Whale Tail 2022 Annual Open Pit Geomechanical Inspection

March 17, 2023

RE: Meadowbank Complex - Amaruq Site - 2022 Annual Open Pit Geomechanical Inspection

2022 Annual Open Pit Geomechanical Inspection

Observations - Phase 1 North Wall

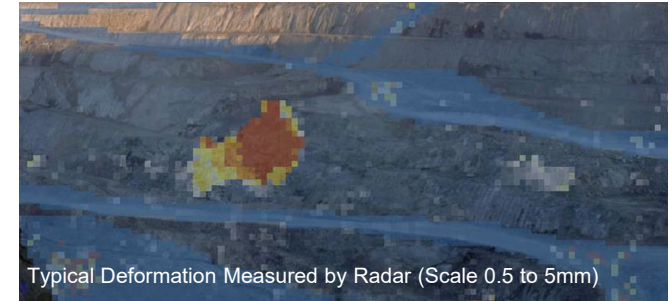
- Interim wall in Phase 1. Phase 1 has been the focus of production over the past year.
- The wall was established in the Komatiite, parallel to the foliation. As expected, a series of bench-scale failures have occurred in areas where the foliation locally dips at a shallower angle than the bench face.

- The implementation of a 55° pre-shear has improved slope performance and half barrels are visible in many areas. Bench-scale failures have and will continue to occur. AEM continues to complete extensive scaling in this sector in order to remove potential hazards and reduce the likelihood of a failure. This is endorsed.

- The bench failures almost always occur during freshet or the summer months.
- As a result, the development of the ramp along the this wall was prioritized during the 2021-2022 winter in order to minimize the rockfall risk to personnel. A berm was installed along the inside of the ramp prior to freshet.

- Two areas of instability have developed along this wall in 2022 (outlined in the image at right) and are described on the following slides.

Observations - Phase 1 North Wall (2)

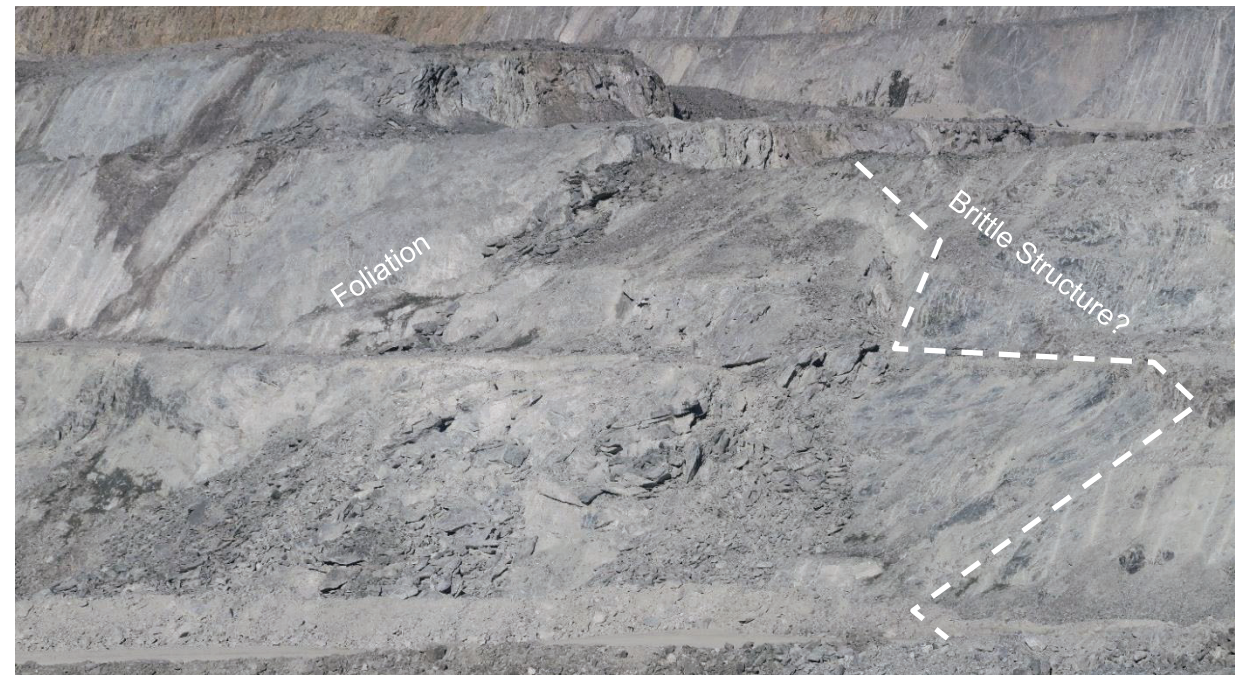
- A multi-bench failure has occurred progressively within the Komatiite over multiple events between May 14 and July 16, 2022.
- The area was identified as a potential instability during development and a berm constructed below the wall prior to freshet.
- The failure appears to be bounded by persistent structures. This could represent an undulation in the foliation, as similar geometries have resulted in bench scale failures in the past. The eastern contact appears to be more linear and may be a Brittle Structure.
- The failure mass continues to exhibit steady, gradual deformation in the radar data, in the order of 5 to 6 mm/day.

Observations - Phase 1 North Wall (3)

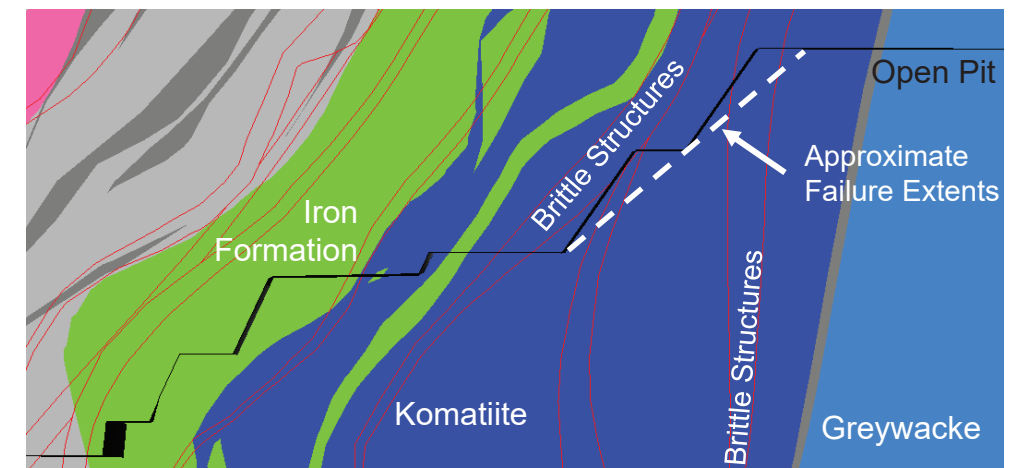
- A review of the lithology model suggests that the failure is unlikely to propagate significantly further back behind the crest due to the presence of the Greywacke.

- The potential for the failure to continue to propagate with depth was discussed as the structure defining the eastern boundary of the failure daylights below the ramp. The failure is larger than others along the Phase 1 North Wall and should be reviewed in greater detail to better understand the failure mechanism, likely contributing factors, and the potential for the failure to continue below the ramp. It may be possible to use the radar data to better understand the possible structural controls on the failure. A Maptek scan is recommended to document the failure geometry in detail.

- The Phase 1 pit will be used as a sump for managing water into 2024. Personnel will be travelling on the ramp below this failure during that time.
- Options for reducing the risk to personnel if the failure continues to progress were discussed. These include:

- Buttressing the failure. This would limit the ramp to single lane traffic but that is expected to be manageable.
 - Allowing the water level to rise a point on the ramp above the failure. This would allow the pumps to be located above the failure, removing the requirement for personnel to travel below the failure. However, the infiltration of water into the toe of the failure mass would like adversely influence the performance of the failure. The potential risks associated with storing this much water above the underground workings would also need to be reviewed.

- The failure should continue to be monitored with the radar and the berm maintained.
- Once mining of Phase 1 is complete, the risks associated with on-going access below the failure should be reviewed and mitigation measures implemented as appropriate.

Observations - Phase 1 North Wall (4)

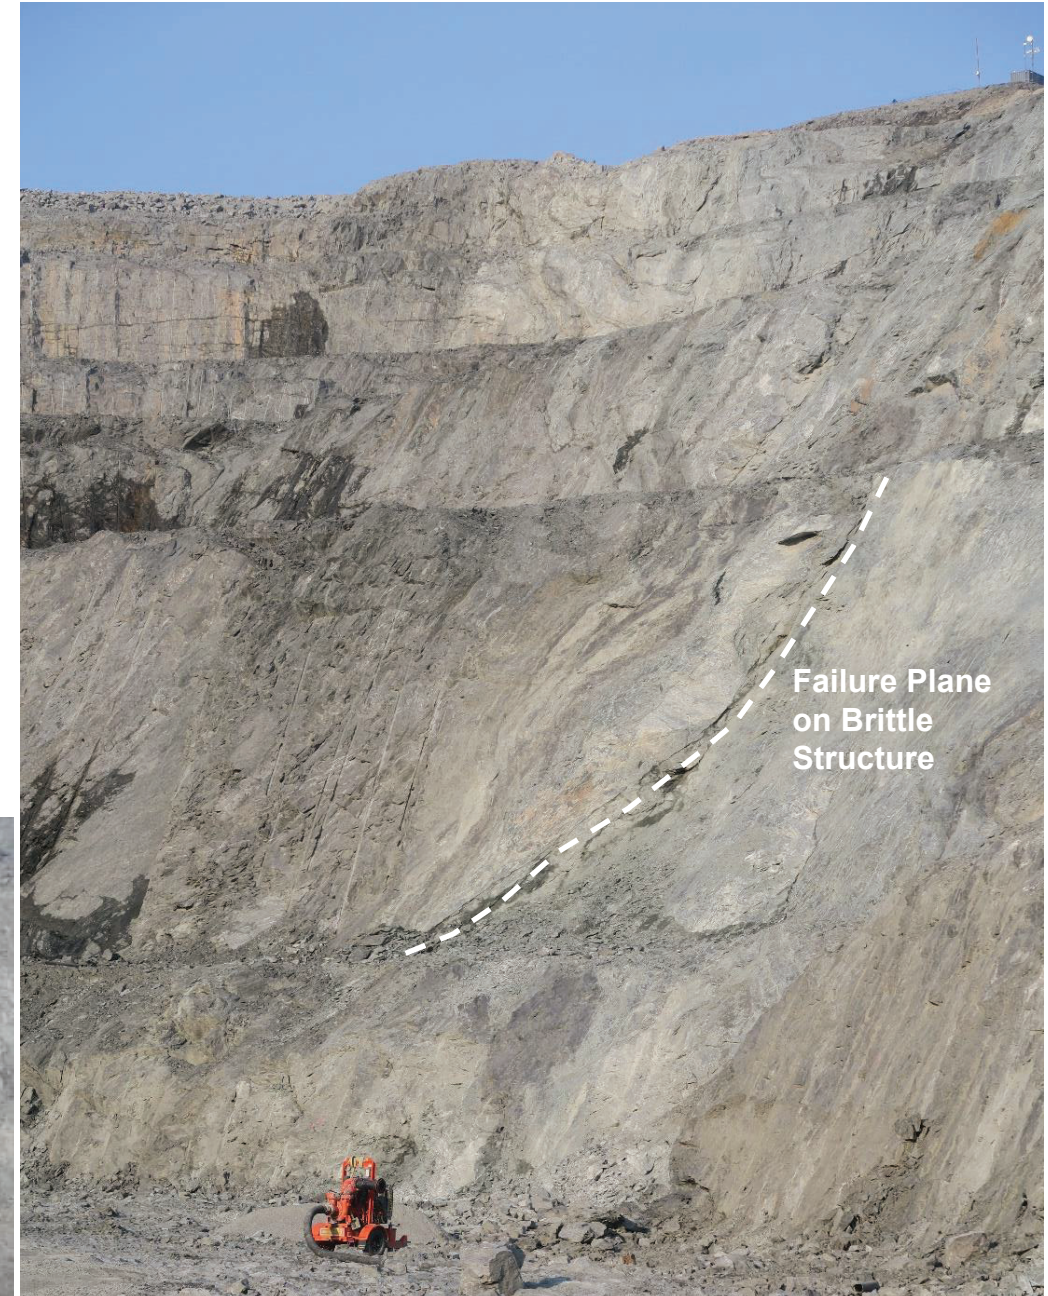
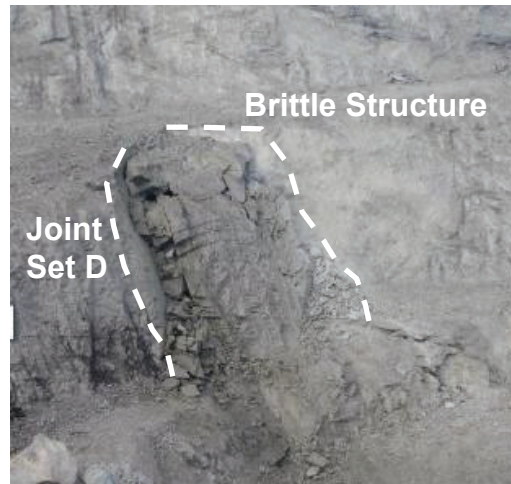
- During the site visit, a possible instability at the western end of the wall was identified based on trends in the radar monitoring data.
- A wedge is present on the wall, formed by a brittle structure and a cross-cutting structure (likely Joint Set D). The rock mass below the brittle structure is Komatiite but it is not clear if the wedge itself is Komatiite.
- The area was barricaded and access prevented. Due to the timing of the event, the pump shown in the photo was left within the barricaded area.
- After the site visit, a portion of the wedge failed in place on August 16 (see inset below). A small step-in with a berm has been left below the failure to allow mining to continue in the area.
The area should continue to be monitored.
- The failure will be mined out when Phase 1 is pushed back to the final pit configuration.

Observations - Northeast Wall

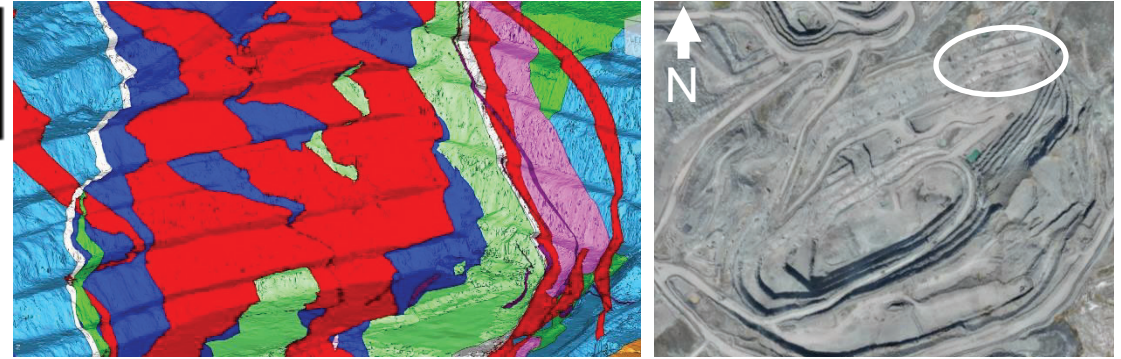
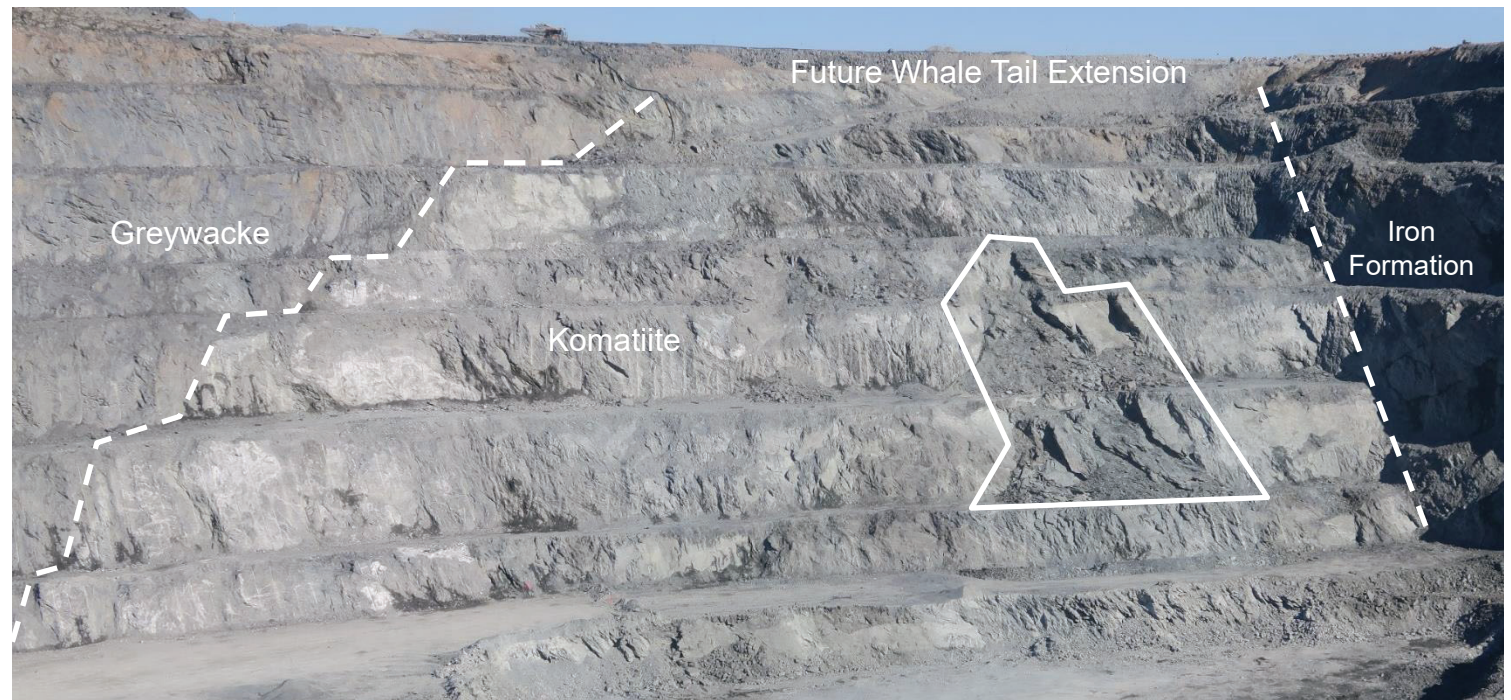
- Final wall in Design Sector D4K.
- This sector is within the Komatiite and has been characterized by a series of bench scale failures. The failures are currently understood to be a hybrid of failure on the foliation and failure of the weak rock mass, influenced by water (i.e., a combination of seepage within the talik and surface runoff) and the Brittle Structures.

- A revised slope design was developed in December 2021 and a pushback of the upper two benches completed to re-establish the slope. The pushback will eventually form part of the planned Whale Tail Extension to the northeast.

- The wall continues to be a focus for the Rock Mechanics team. Assessments of the overall slope stability using a numerical model and of the planned lower wall using kinematics are in progress.

- The performance of the benches has improved with the revised slope design. Several bench-scale failures have occurred and will continue to occur.
- A series of bench-scale failures have occurred at the eastern end of the sector (outlined at right). The failures have almost, but not yet, linked up. This area is discussed on the following slide.

Observations - Northeast Wall (2)

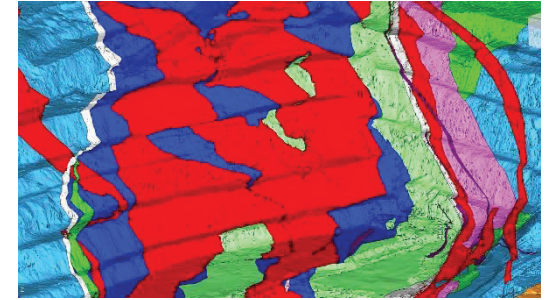
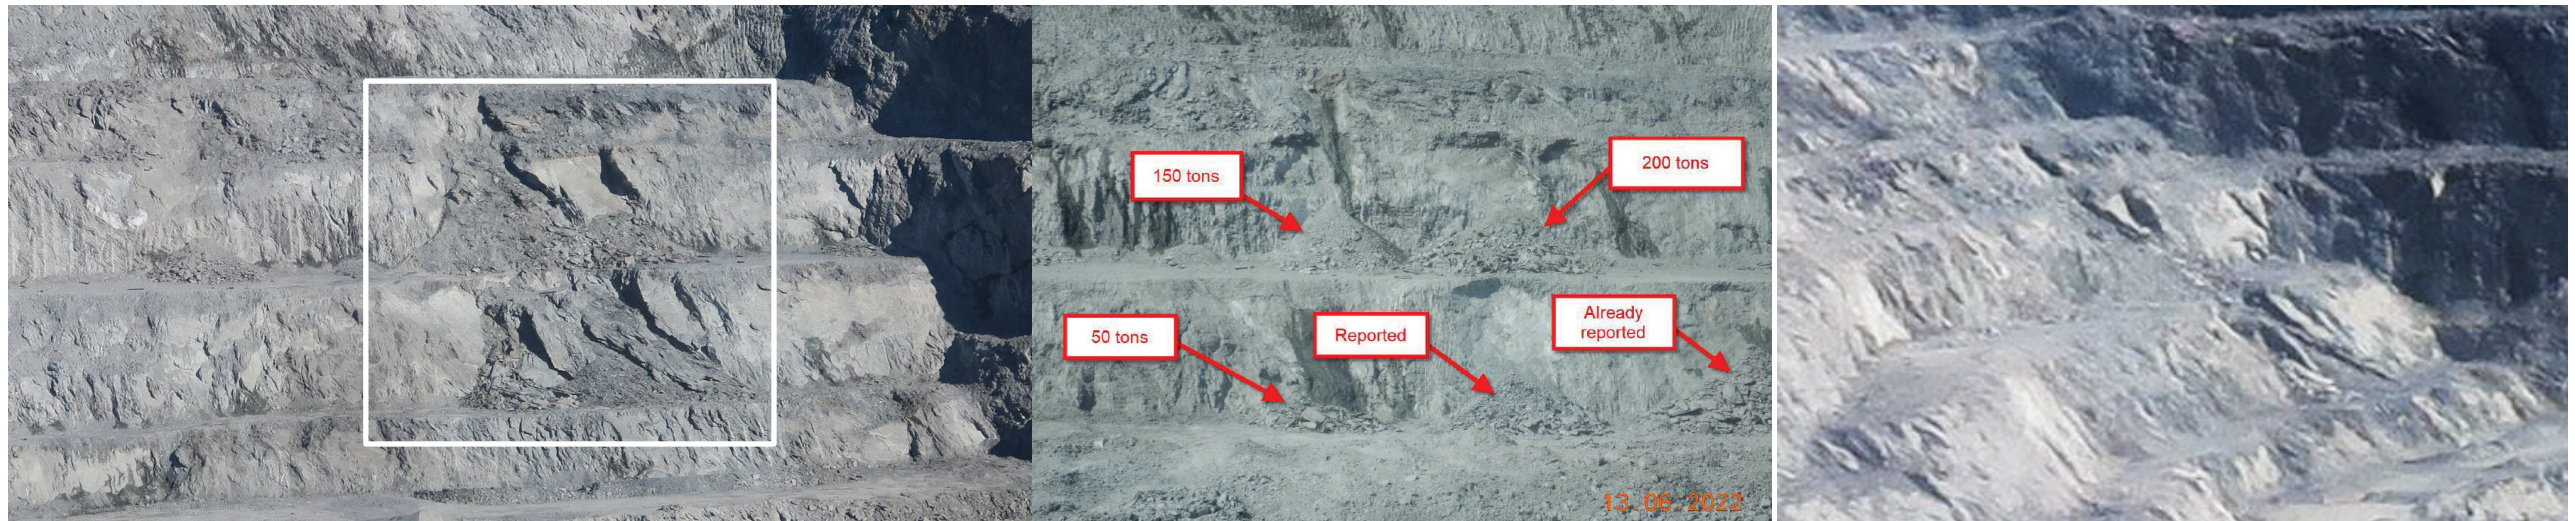
- Seven rockfalls and bench scale failures have been reported in this sector in 2022, ranging in tonnage between approx. 150 and 1500 tonnes. All but one are associated with a series of progressive failures associated with the area outlined in the left photo.

- The failures occurred during freshet, between May 28 and July 17, with most occurring in June. Failures were expected and a rockfall berm was constructed below this area prior to freshet.

- The middle photo shows the outlined area at the time of many of the initial failures in June. These failures were relatively small and several appear to be associated with surface water or erosion of the face (see next slide). The rock mass quality was noted to reduce as the rock mass thawed and these failures progressed over time. The failures on the two benches have almost linked up.

- The western limit of the failures appears to be defined by the foliation. The eastern limit of the failures appears to have a structural control (see right photo). This may be one of the brittle structures (see image at upper right, with brittle structures in red).

Observations - Northeast Wall (3)

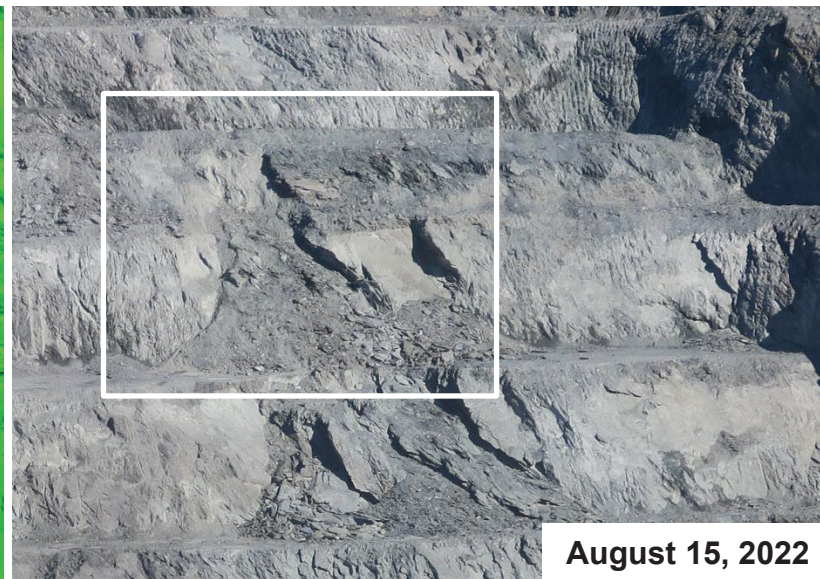
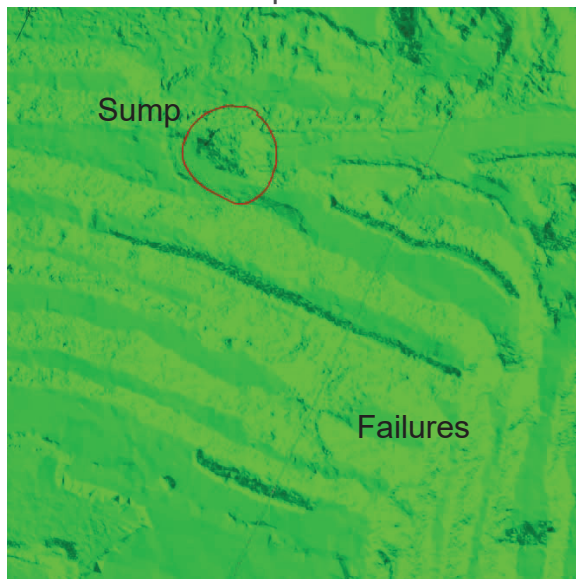
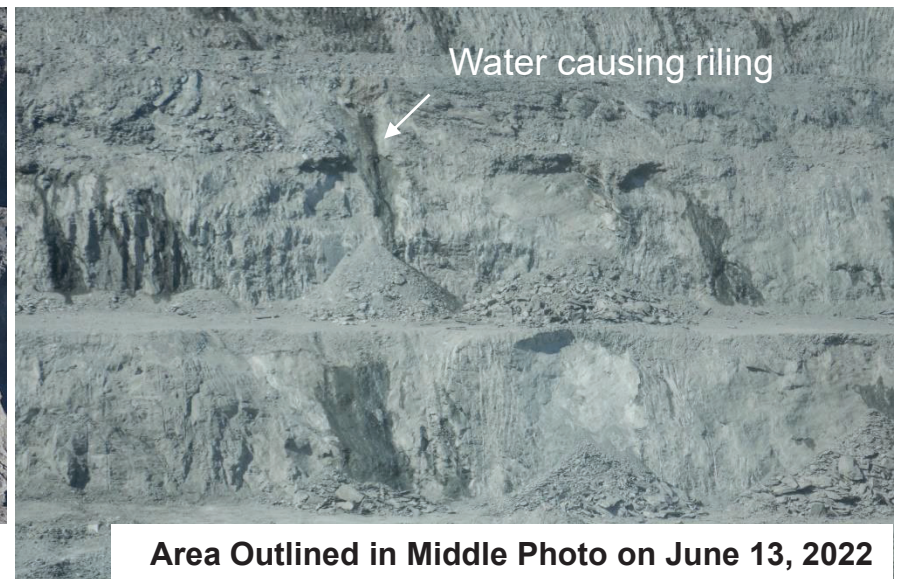
- The site team believes that the infiltration of surface water and the erosion of brittle structures in the bench face likely contributed to the initial failure in May.

- The pushback is located within the drainage for what was the northeastern lobe of Whale Tail lake and water reports to the area. An unlined sump has been established at the base of the pushback at the top of the slope (left photo). The sump is on the Komatiite-Greywacke contact, which is likely promoting infiltration.

- Photos prior to the failures show surface water running across the bench face and eroding the weak rock mass (right photo). The water appears to be concentrated along the potential structure bounding the western edge of the failures.

- It seems reasonable that water is contributing to the failures. It is recommended that surface water be diverted away from the area to the extent possible and that the sump be lined.

Observations - East Wall

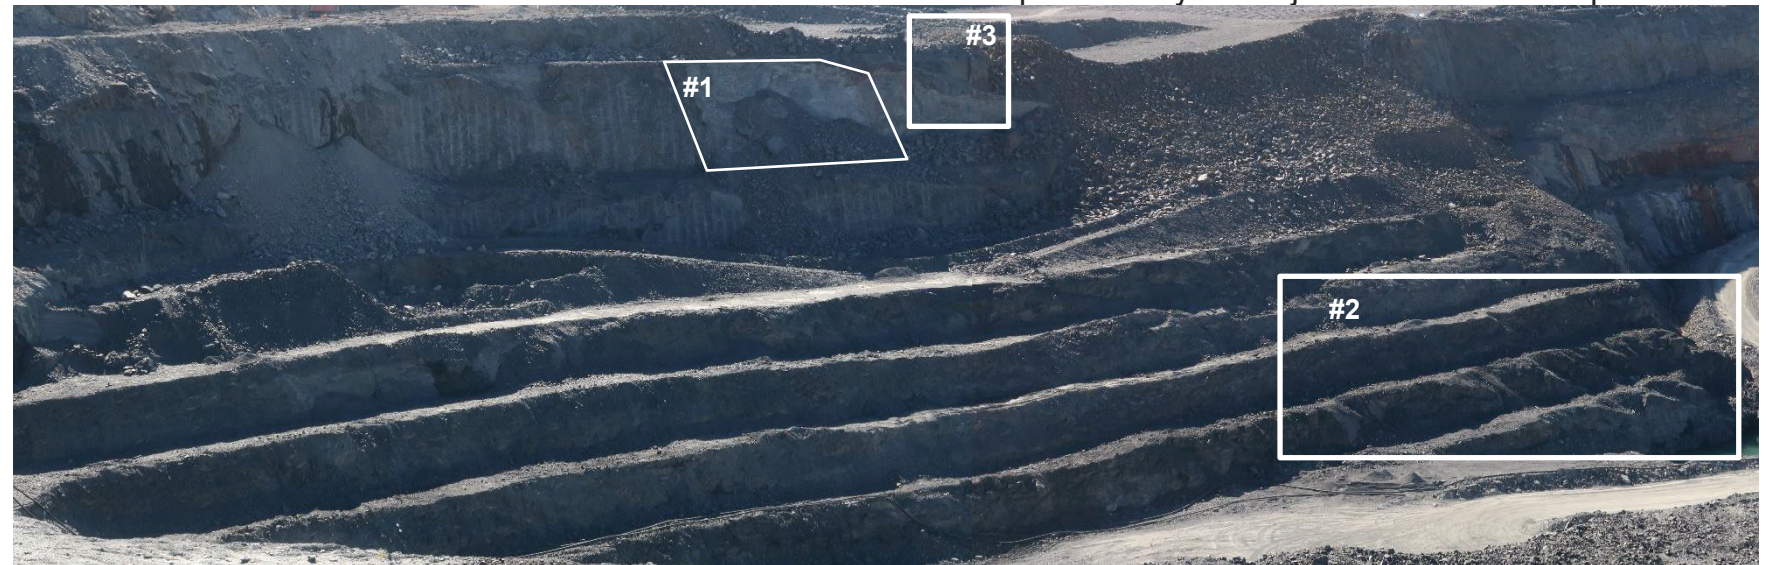
- Final wall in Design Sector E4.
 - Limited mining has occurred along this wall since the 2021 review. Specific areas of note are listed below and outlined on the photo.

1. Material from a former in-pit dump remains on the face of the upper bench. A rockfall berm was constructed to retain ravelling material. No significant changes have been observed.

2. The Greywacke near the Diorite has experienced crest loss and previous rockfall events. A temporary step-out has been left below the area to reduce the exposure to personnel. The intention is to scale the area, clean the catch benches and recover the step-out as part of the Phase 3 pushback. This is endorsed. Several potentially unstable blocks were previously identified and should continue be monitored as part of the visual inspections. The drone should be used to supplement these inspections.

3. A joint set cross-cutting the foliation and dipping to the north is prominent in the Iron Formation near the Komatiite contact. It has locally resulted in increased crest loss.
